From: [Cherry Diefenbach](#)
To: [Harris, Susan](#); [Koutoufidis, Nicholas](#); [Jacob, Dianne](#)
Subject: Comments on the JVR Energy Park (PDS2018-MUP-18-022) DEIR
Date: Wednesday, December 02, 2020 11:58:04 AM
Attachments: [Cherry Diefenbach"s commnets on the jvr solar DEIR Dec 2, 2020.docx](#)

RE: JVR Energy Park (PDS2018-MUP-18-022) DEIR Comments

Visual Simulation of the Project

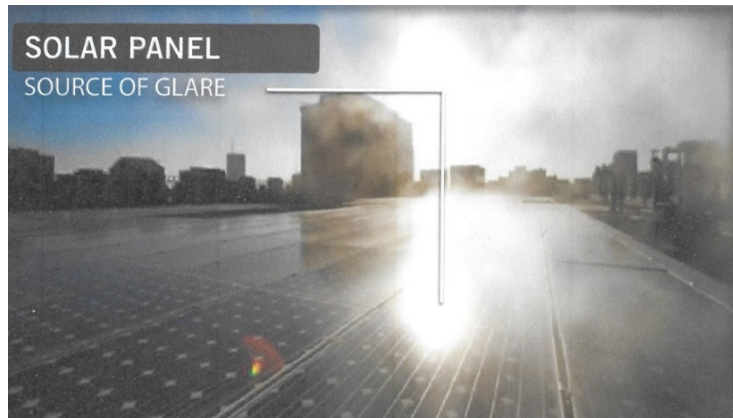
--A visual simulation of the tunnel-like view that east or westbound motorists travelling on Hwy 80, a county-designated scenic highway that runs through Jacumba would experience. The setback from right of way (ROW) north of Hwy 80 is 65 feet and the setback from the ROW

south of Hwy 80 is just 45 feet. The DEIR provides a misleading long-distance visual simulation from Airport Mesa looking west toward Jacumba that shows significantly wider setbacks along the south side of Hwy 80 and along the border fence. (See arrows in DEIR Figure 2.1-16 below.)

--A visual simulation of solar panels, three battery storage units, an inverter and a transformer on the low hill where vacant farm buildings are currently located. A six-foot high slatted fence at grade level along Hwy 80 will not adequately screen solar equipment from motorists or homes. (See 2019 photo of the project area including farm buildings, indicated with an arrow, as seen from a hillside location in town.) It is interesting to note that all those omitted visual simulations would show the project's most severe impacts to aesthetics. **Add additional visual simulations to the EIR as indicated above.**

Single Axis Tracker Behavior

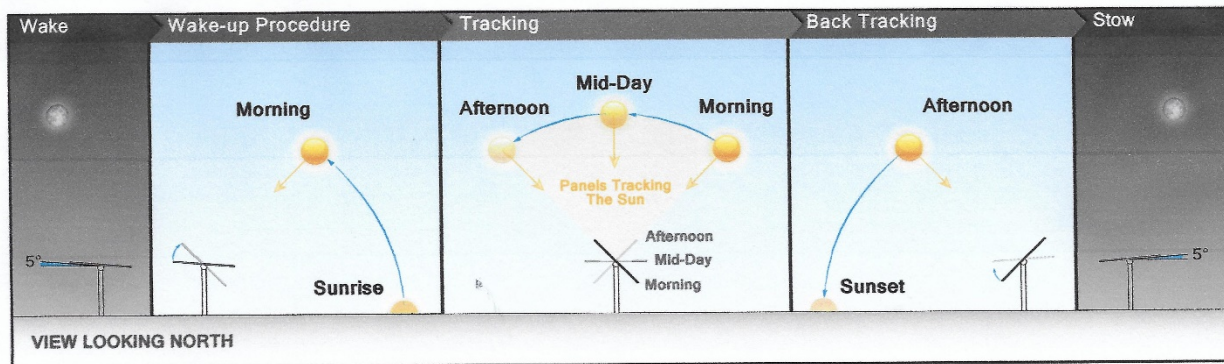
properties” (2.1-44). The project’s glare study also analyzed potential glare distractions to motorists and nearby structures based on a viewer height of 10 feet and then it erroneously concluded Jacumba residences would not be impacted by solar panel glare. The DEIR further states that the “5-degree wake/stow angles would cause any potential glare to be directed above and away from analyzed sensitive viewers residential locations and motorists on I-8, Carrizo Gorge Rd, and Old Hwy 80” (2.1.47). That statement doesn’t make any sense. The solar panels are in the wake/stow positions before they begin to track the east-west movement of the sun and also when the sun is directly overhead. (See Figure 6 from the glaze study below.)

Within the DEIR there is some confusion as to the orientation of the solar arrays. While the glare study describes an east/west tracking pattern for the solar panels, it also states “the solar facility would be directed southward toward the sun (2.6-35). **Clarify solar panel tracking and alignment.**
